**Re: Drainage Report Addendum for La Cuentista II  
Engineer's Stamp Date 1-12-15 (D10D002B)**

**Drainage Report  
ADDENDUM  
for  
LA CUENTISTA  
SUBDIVISION, UNIT II**

**Re: Drainage Report Addendum for La Cuentista II  
Engineer's Stamp Date 12-30-14 (D10D002B)**

**To:** Curtis Cherne, P.E.**From:** Daniel Aguirre, P.E.**CC:** File14-600-08900**Date:** January 12, 2015**File Number:** 14-600-089-00**Re:** La Cuentista Unit II Drainage Report Addendum 01

Drawing 15		Drawing 15		Drawing 15		Drawing 15		Drawing 15	
Sheet 37		Sheet 37		Sheet 37		Sheet 37		Sheet 37

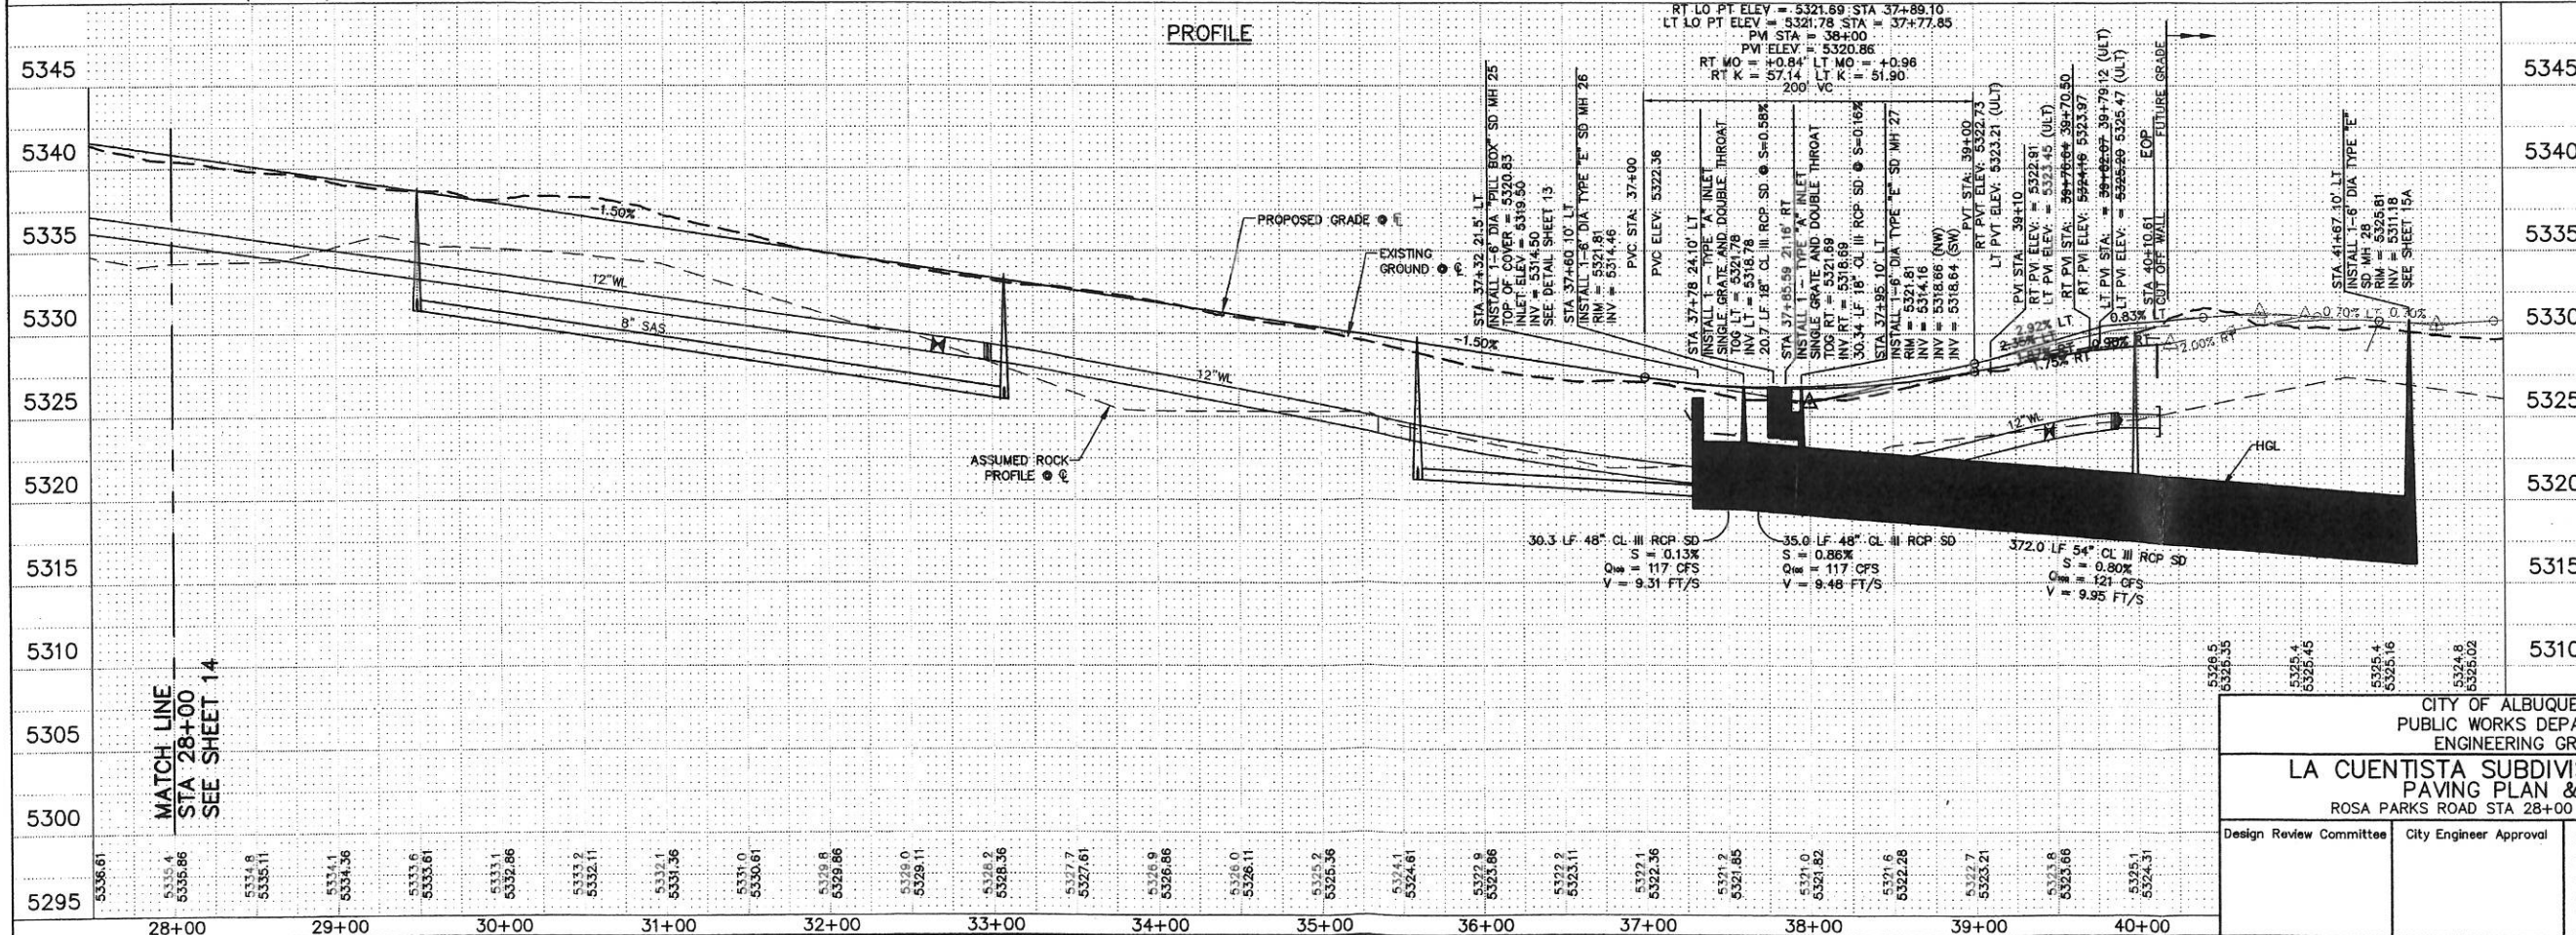
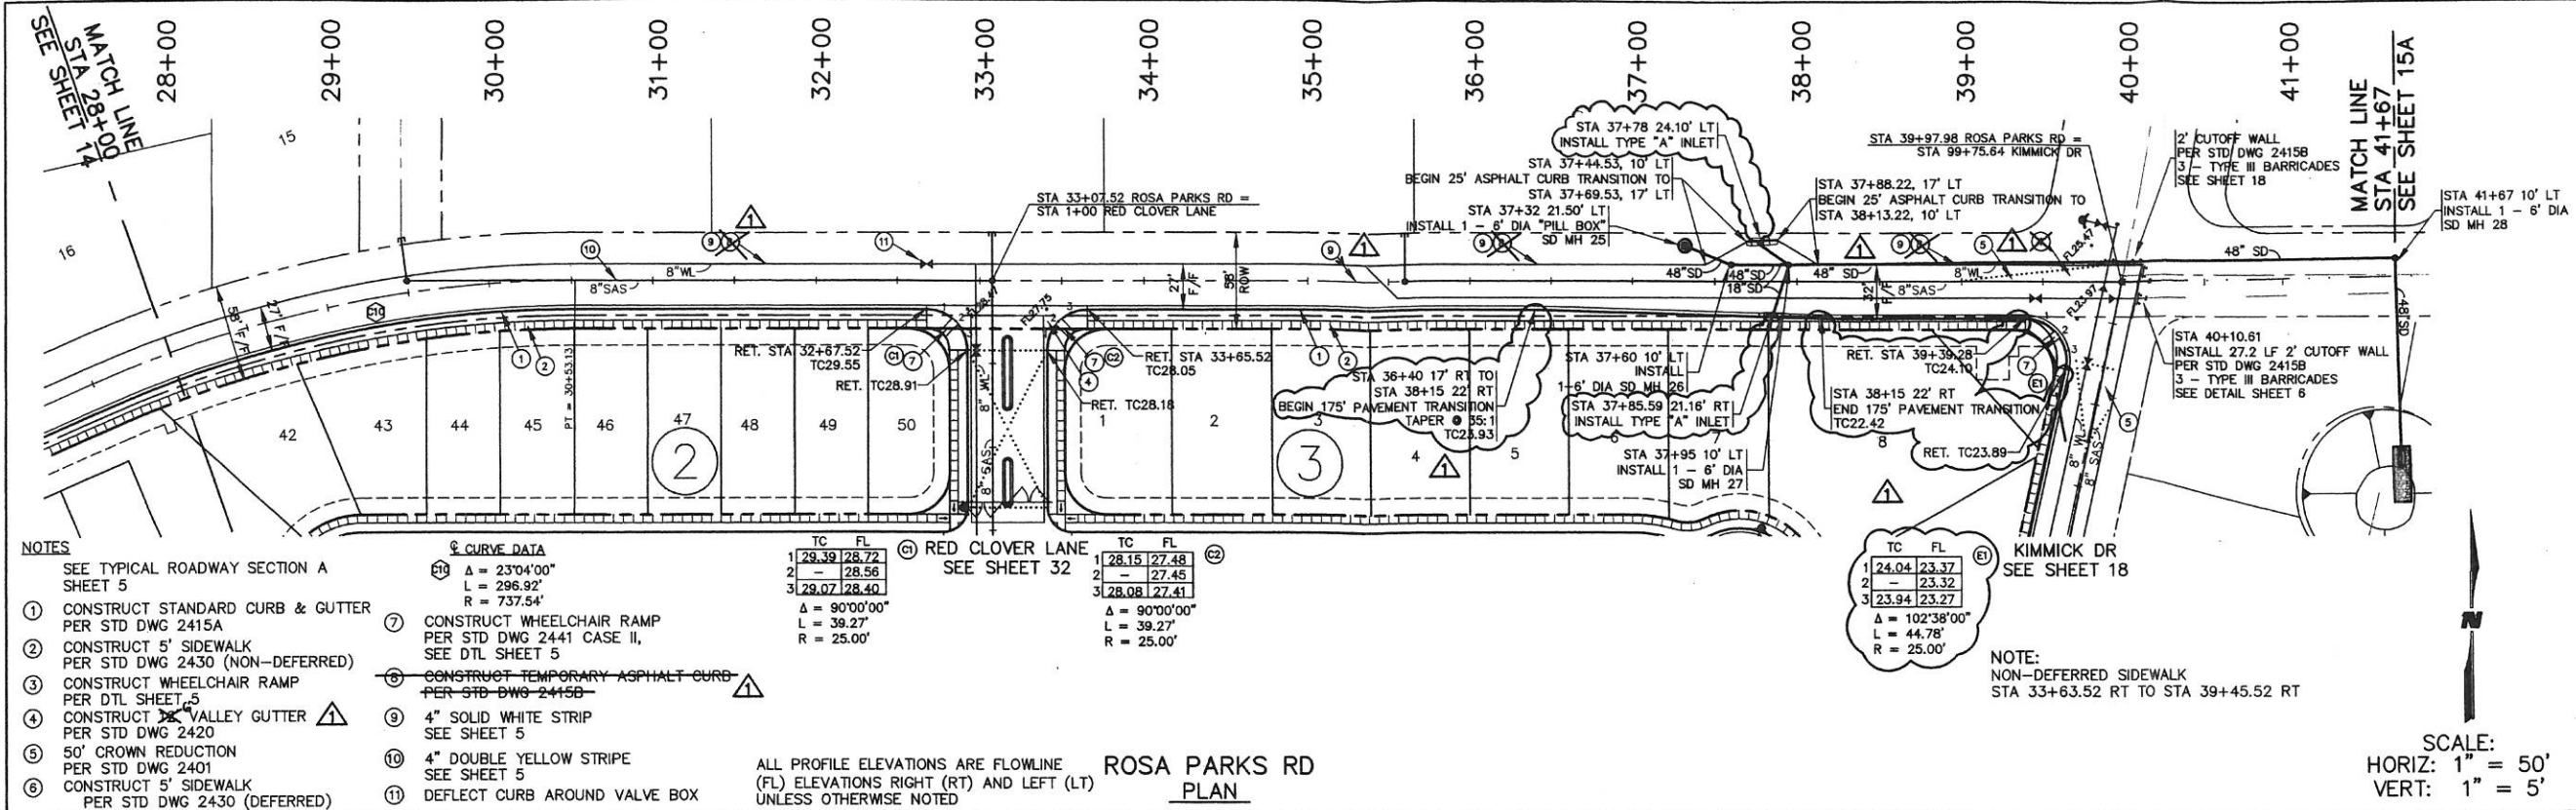
5. It appears the last sheet in the report (sheet 15 of 37) may have been mislabeled as with AP-3. Isn't this sheet applicable to AP-4?

## SURVEY ELEVATIONS AT PILL-BOX INLETS

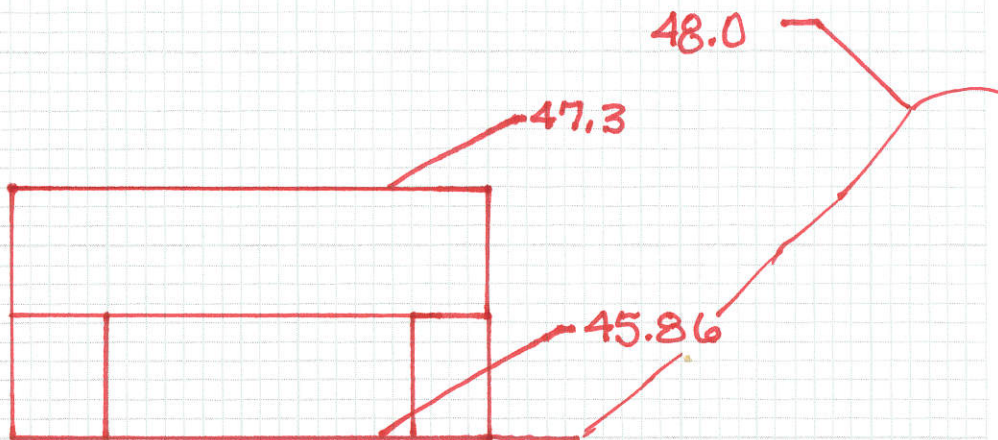
3. The sump inlets in the north side of Rosa Parks were constructed without a permanent section. How will the water surface elevation required for the head used in the orifice equation be obtained?

The Pill Box Inlet Structures were both constructed in low areas and operate as orifices once the water exceeds the top of the opening.

Headwater Elevation	26.20	ft
Centroid Elevation	24.38	ft
Tailwater Elevation	0.00	ft
Discharge Coefficient	0.70	
Opening Width	14.50	ft
Opening Height	1.00	ft
